PLAN COMMISSION
MINUTES
AUGUST 9, 2012

PRE-APPLICATION MEETING – 760 SHEEHAN AVENUE, AMBER RIDGE SUBDIVISION. SECOND PRE-APPLICATION MEETING REGARDING THE PROPOSED SUBDIVISION OF 9 ACRES LOCATED AT 760 SHEEHAN AVENUE INTO 23 NEW SINGLE-FAMILY HOME LOTS. THE SUBJECT PROPERTY IS LOCATED AT THE NORTHWEST CORNER OF ROUTE 53 AND SHEEHAN AVENUE IN THE R2 RESIDENTIAL ZONING DISTRICT.

TO: Glen Ellyn Plan Commission

At your request we have reviewed the Conceptual Site Plans undated prepared by Spaceco Inc. for the development of a vacant parcel along Sheehan Avenue at the northwest corner of Sheehan and Illinois Route 53. The parcel extends west of the south end of the Montclair Avenue right-of-way. The land is zoned R2 and single family development is proposed. In each concept, the low land to the east will be detention and wetland. The concept site plans offer choices in connectivity to the existing streets.

CONCEPT SITE PLAN 5
LONG CUL-DE-SAC

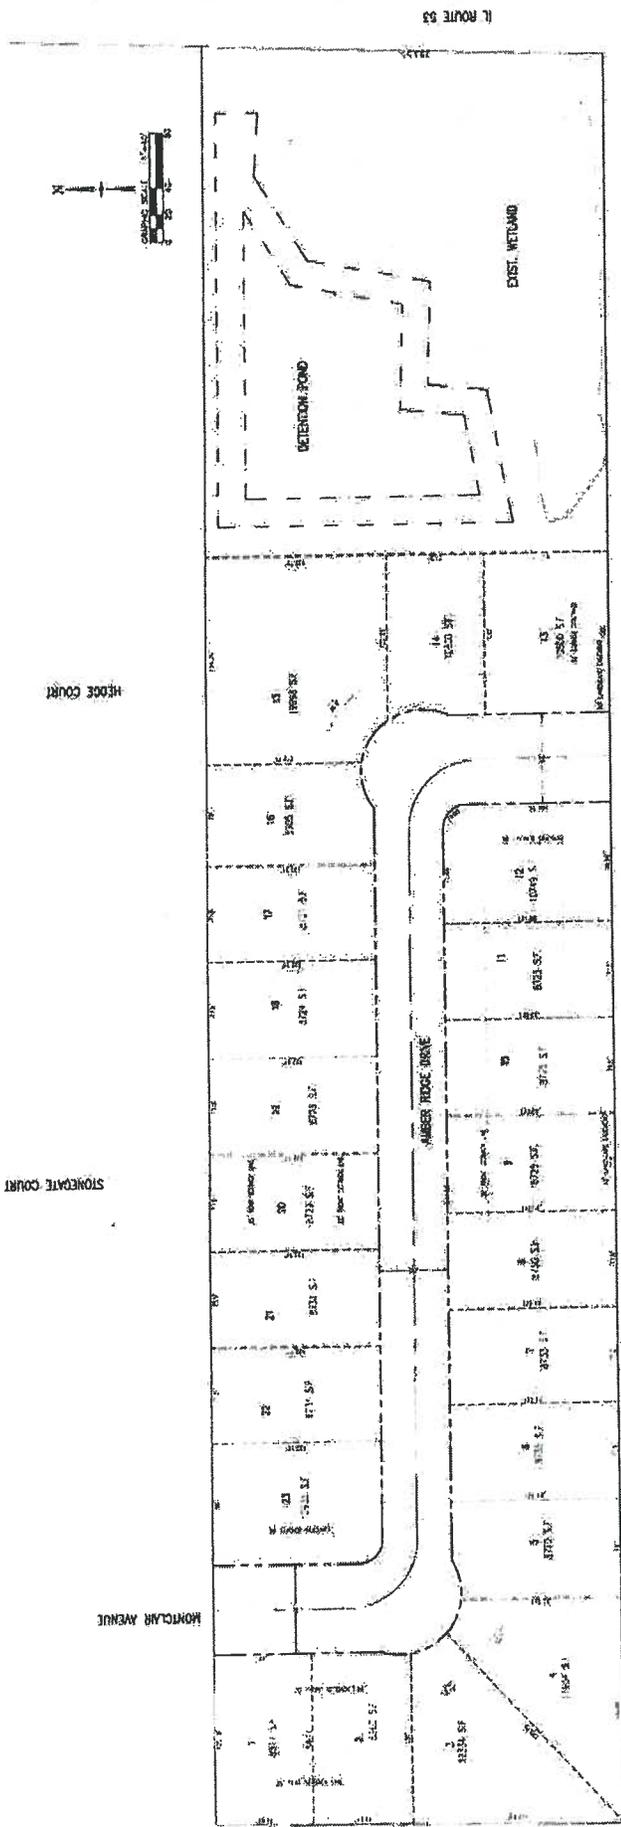
Concept Site Plan 5 – the long cul-de-sac
Extend Montclair to offset cul-de-sac with no Sheehan connection (24 homes)

- Pro
 - Will not increase cut-through traffic within the existing neighborhood
 - No parking loss of Sheehan on-street parking
 - Eliminates the Montclair Avenue dead-end.

- Con
 - No vehicular or pedestrian connection to the south may conflict with the "convenient roadway system" requirement of Section 403 of the Subdivision Regulations Code.
 - The 1,200' length of cul-de-sac exceeds the 500' limit in Paragraph 10-403-10a of the Subdivision Regulations Code.
 - The longer a cul-de-sac, the larger number of residences that may be isolated during routine maintenance or emergency response operations.
 - Of all the concepts, this one adds all additional generated traffic onto existing Montclair Avenue.

CONCEPT SITE PLAN 1
1ST LAYOUT

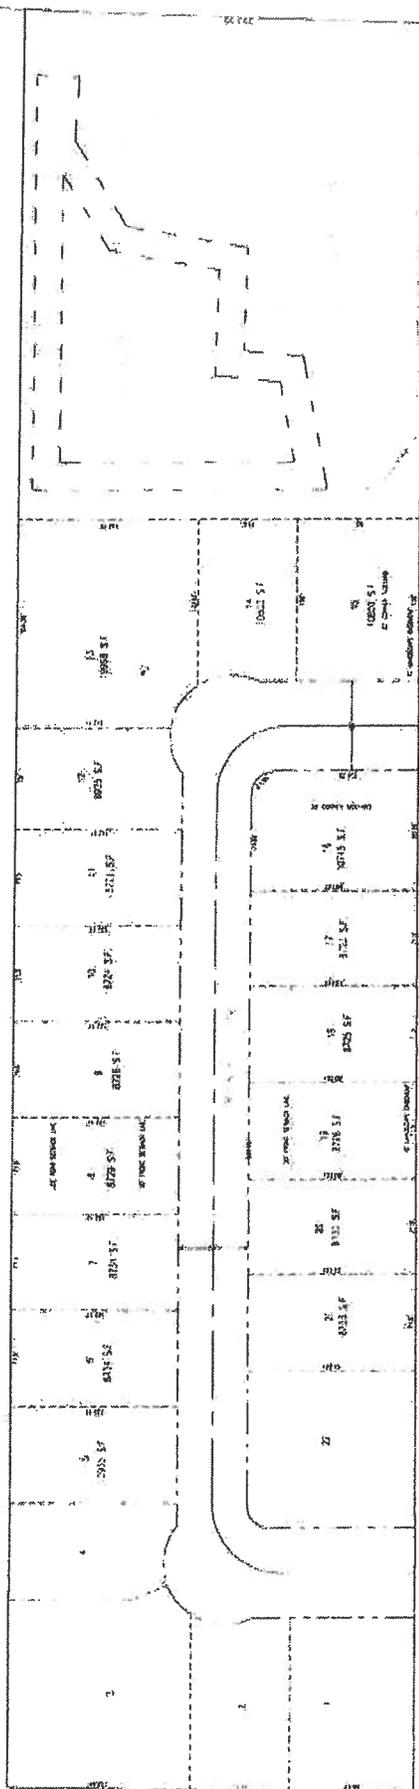
Concept Site Plan 1 – the "S" layout

CONCEPT SITE PLAN 4
"J" LAYOUT

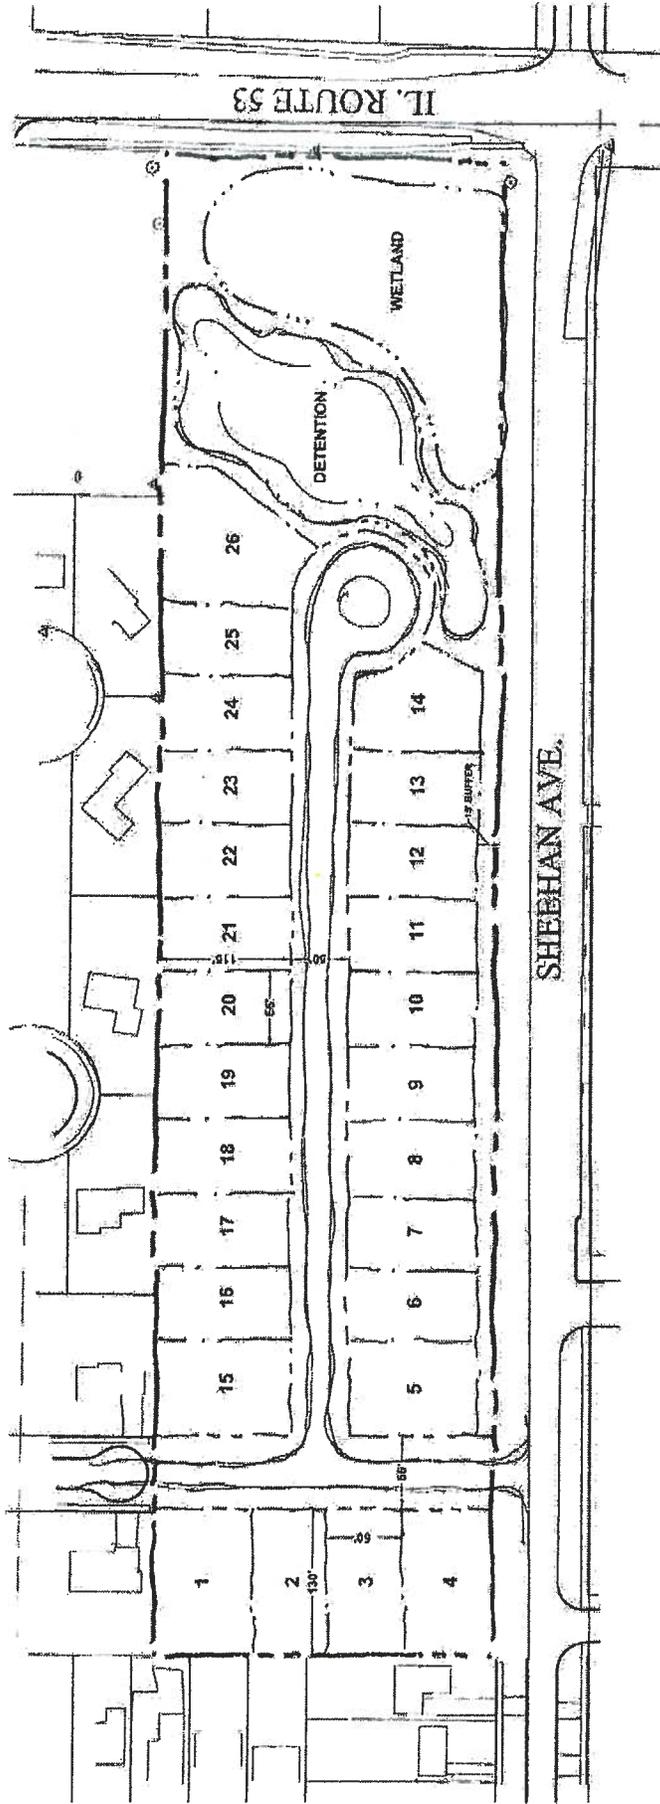
Concept Site Plan 4 – The “J” layout

- Pro
 - Provides connectivity to north and south for vehicular and pedestrian traffic – maximizing mobility for area residents.
 - Eliminates the Montclair Avenue dead-end.
 - Montclair Avenue extension is consistent with past discussions.
 - No parking loss on Sheehan.
- Con
 - Length of cul-de-sac exceeds the 500' limit in Paragraph 10-403-10a of the Subdivision Regulations Code.
 - West connection to Sheehan falls between the two main school driveways, introducing additional conflict points in the vicinity of the busiest school access points.
 - Straight connection from Montclair to Sheehan has higher potential for cut-through traffic movements between Park Boulevard and Route 53 because a straight route is visible.

Potential Detached
Garage Plan – 3,520 SF

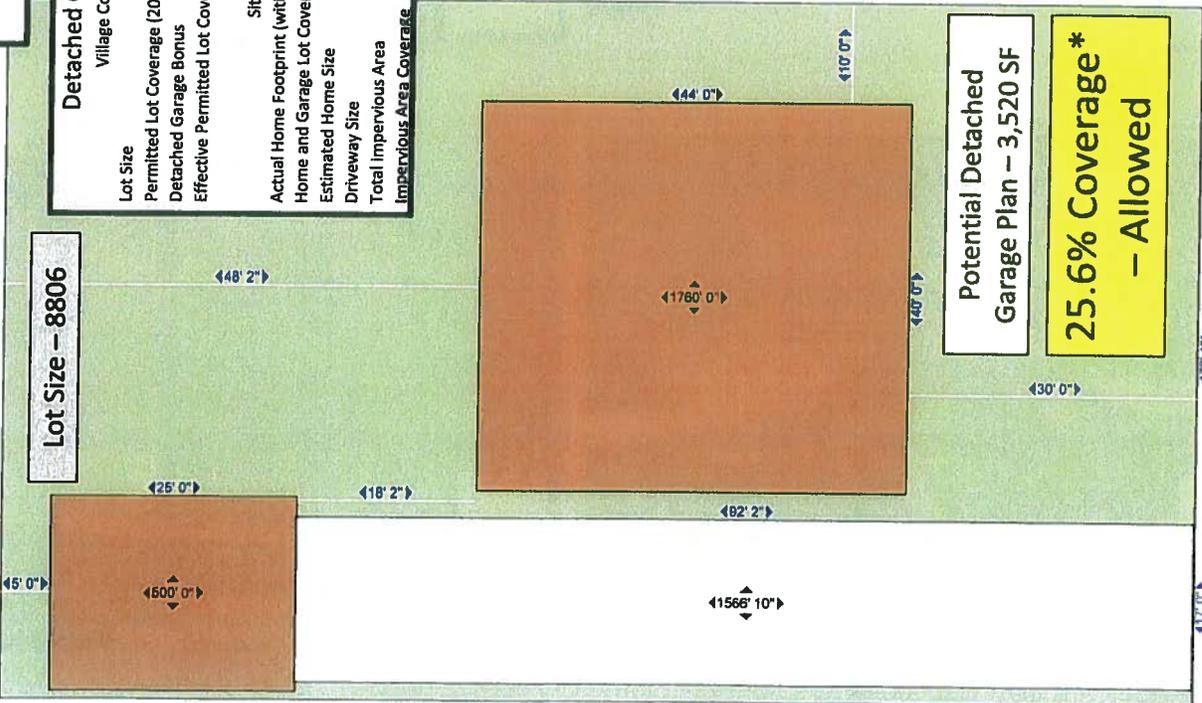
Detached Garage Home	
Village Code Permitted	
Lot Size	8806 SF
Permitted Lot Coverage (20%)	1761 SF
Detached Garage Bonus	500 SF
Effective Permitted Lot Coverage	25.68%
Site Stats	
Actual Home Footprint (with garage)	2260 SF
Home and Garage Lot Coverage *	25.66%
Estimated Home Size	3520 SF
Driveway Size	1566 SF
Total Impervious Area	3826 SF
Impervious Area Coverage	43.45%

K. Hovnanian's
Stewart Plan – 2,827 SF

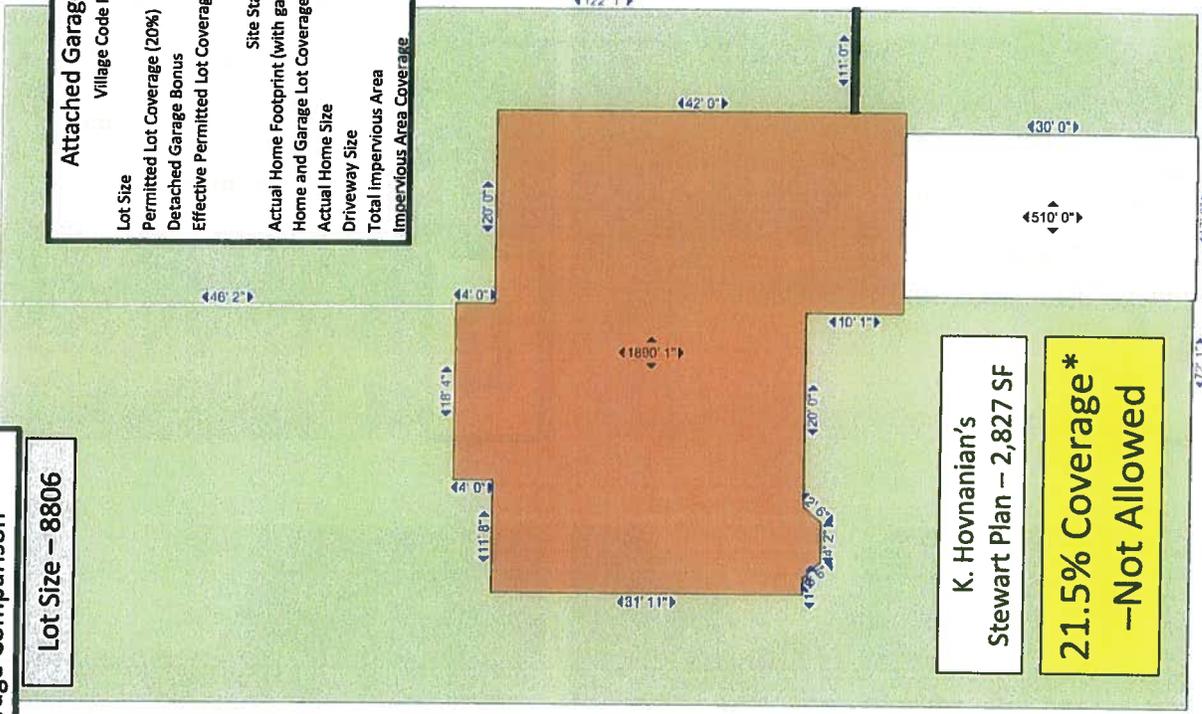
Attached Garage Front Entry	
Village Code Permitted	
Lot Size	8806 SF
Permitted Lot Coverage (20%)	1761 SF
Detached Garage Bonus	0 SF
Effective Permitted Lot Coverage	20.00%
Site Stats	
Actual Home Footprint (with garage)	1890 SF
Home and Garage Lot Coverage *	21.46%
Actual Home Size	2827 SF
Driveway Size	510 SF
Total Impervious Area	2400 SF
Impervious Area Coverage	27.25%

Suggested Detail

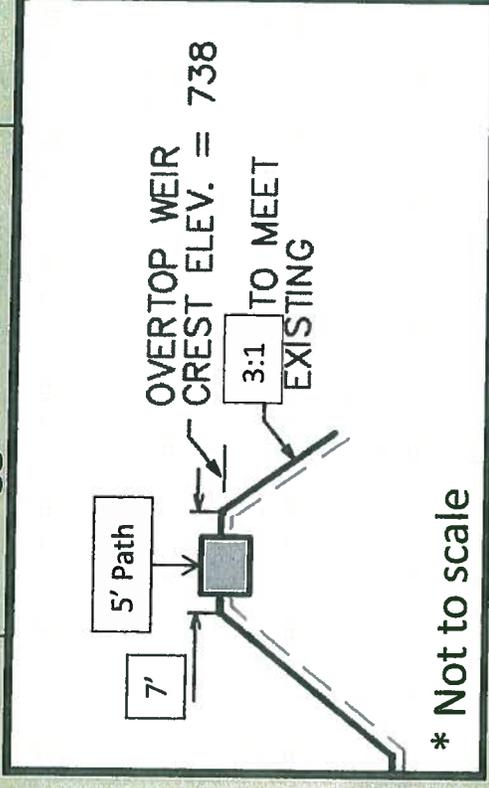
- **Suggested path detail creates life safety issues.**

Original Condition

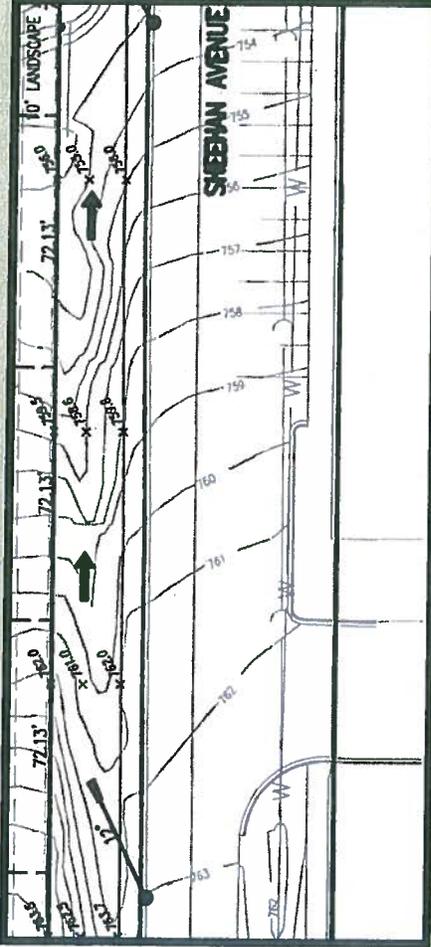
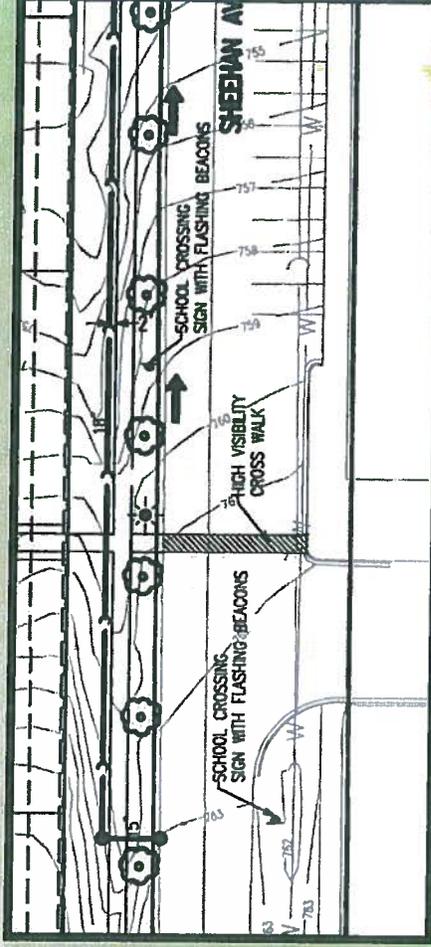
- Open swale conveyance of storm water
- No parkway trees
- No lighting
- No Crosswalk or signage
- 6' sidewalk directly adjacent to curb

- Closed pipe conveyance of storm water
- Parkway Trees added
- High Visibility Crosswalk added with school crossing beacons. Aligns with new path.
- Street light added at crosswalk
- 5' sidewalk seven foot from the back of curb
